THE CITY OF KEY WEST

Tree Commission

STAFF REPORT

RE: Key West Historic Seaport (permit application # T18-8977)

L-3.0

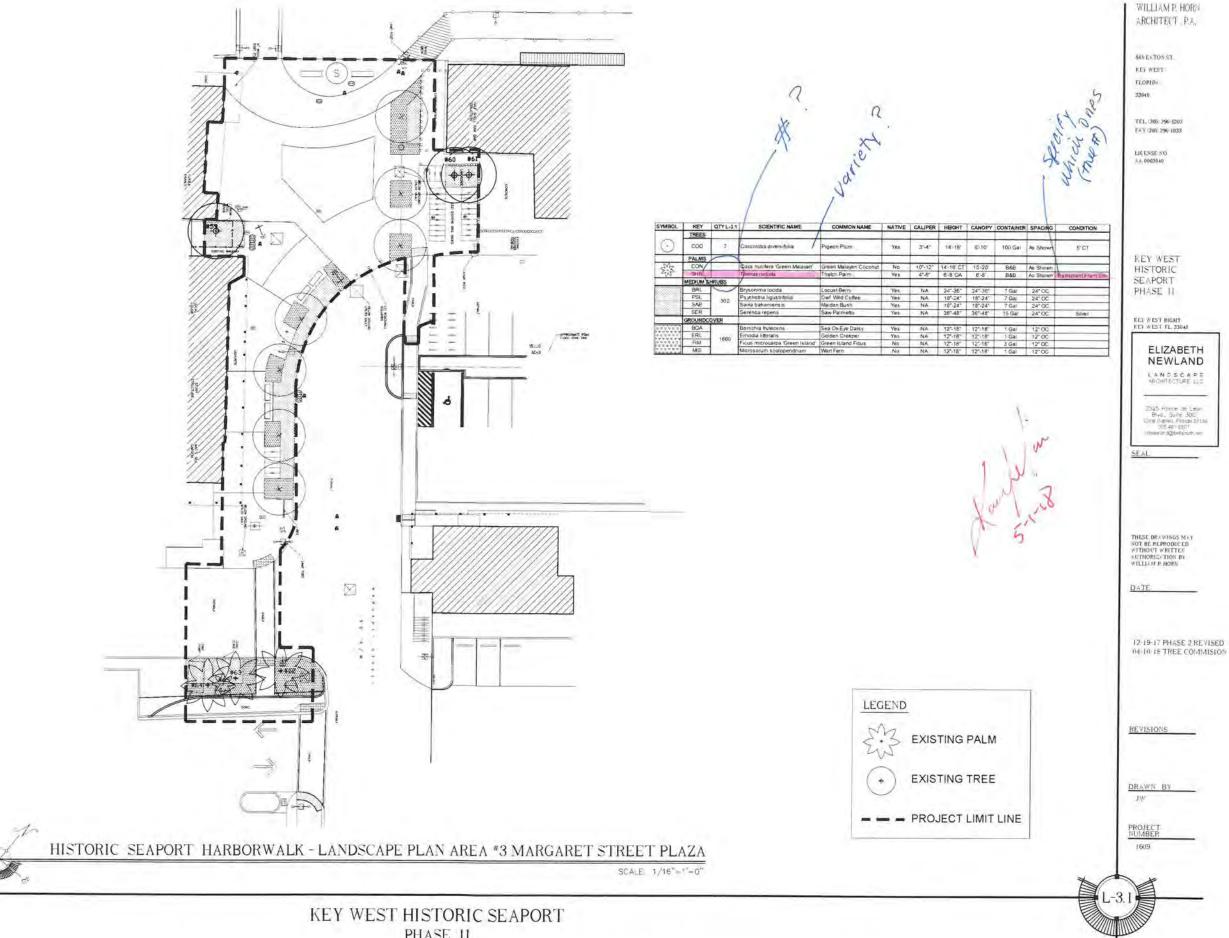
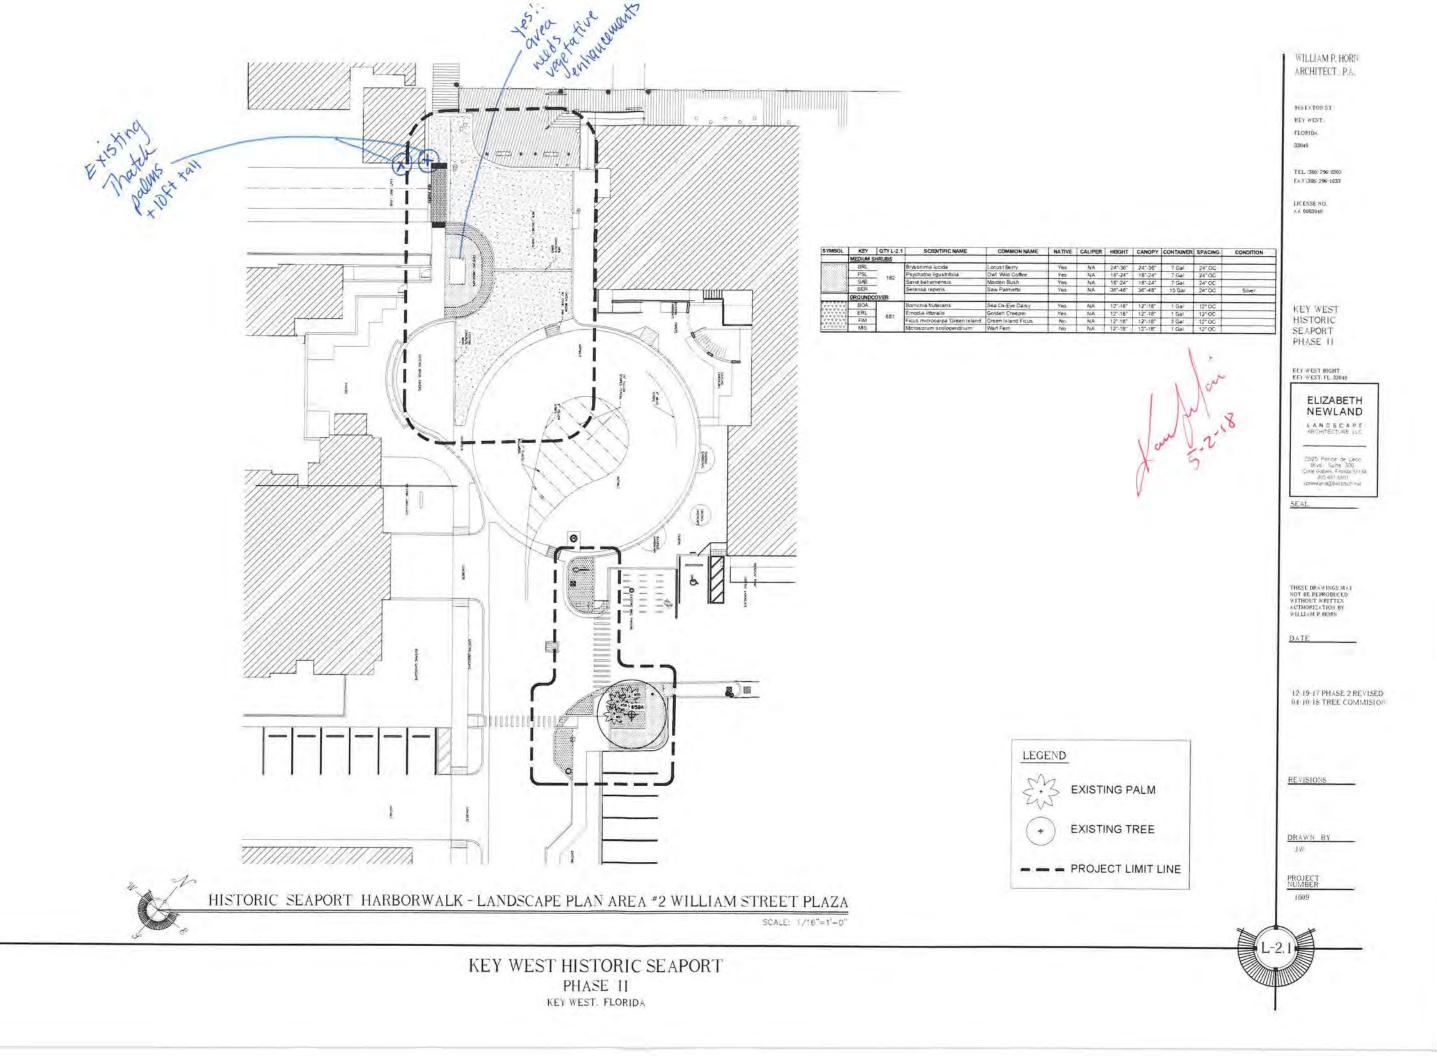
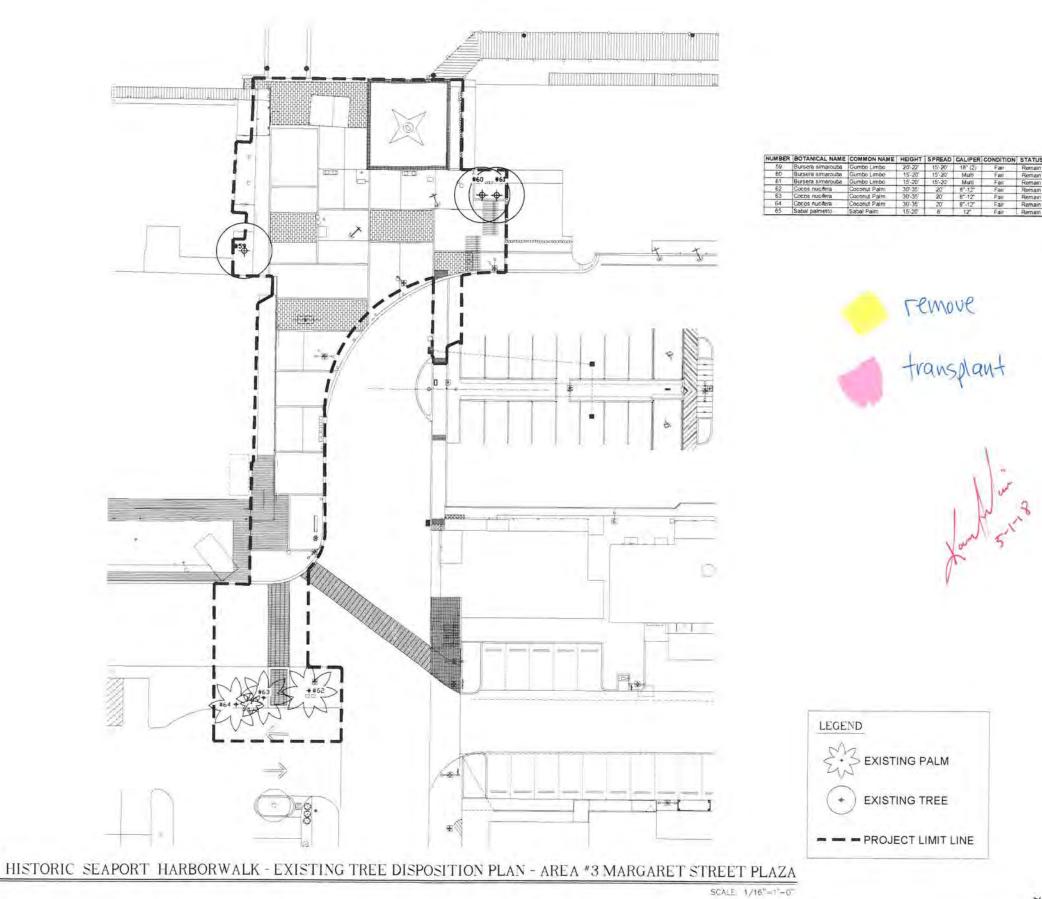
If permits were approved today, the proposed landscaping does not incorporate the required tree replacements. It appears to incorporate most if not all the required palm replacements for this area and does incorporate the Thatch palm transplants. Where will the coconut palm transplants be planted?

Do not recommend the planting of saw palmetto in the area as it has a low traveling growth and thorny type structures along the petiole of the frond.

Also, final plans need to include a tree protection plan for proposed work near the trees and palms.
